# UNITED STATES PATENT AND TRADEMARK OFFICE

APPLICATION NO.	FILING DATE	FIRST NAMED INVENTOR	ATTORNEY DOCKET NO.	CONFIRMATION NO.
10/617,018	07/11/2003	I-Fong Chen	BHT-3103-147	2704
7590	06/22/2005		EXAMINER	
BRUCE H. TROXELL SUITE 1404 5205 LEESBURG PIKE FALLS CHURCH, VA 22041			CUMMING, WILLIAM D	
			ART UNIT	PAPER NUMBER
				2683

<b>Office Action Summary</b>	<b>Application No.</b>	<b>Applicant(s)</b>	
	10/617,018	CHEN	
	Examiner WILLIAM D CUMMING	Art Unit 2683

**Figure 4**

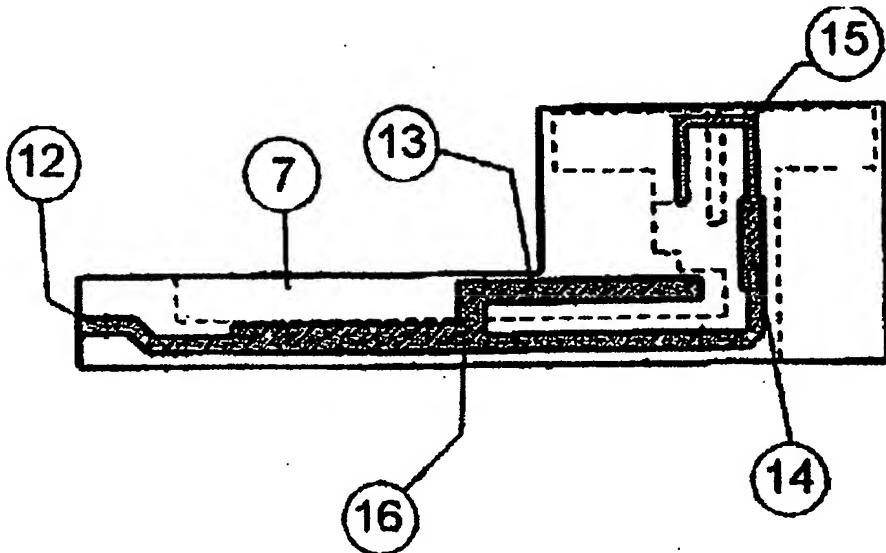
7. Claims 1 and 3 are rejected under 35 U.S.C. 102(e) as being clearly anticipated by **Petropolous**.

**Petropolous** discloses a hidden planar antenna module (figure 4) for a mobile phone (Paragrpah 22), said module is provided with a base plate having a predetermined area (figure 4), said base plate has on a surface thereof a first micro-strip section (#14) and a second micro-strip section (#13) being in relation with wavelengths of corresponding operation frequencies; the front ends of said micro-strip sections make an open circuit, the tailing ends of said micro-strip sections are connected to be used as a third micro-strip section of a feed line (#16); said second micro-strip section (#13) connected with said tailing end of said first micro-strip section forms an open stub for adjusting frequency width and impedance matching; said module is characterized by that: said feed line is connected with micro-strips of a related circuit (#12) and a grounding line to form said antenna module with a coplanar wave guide effect.
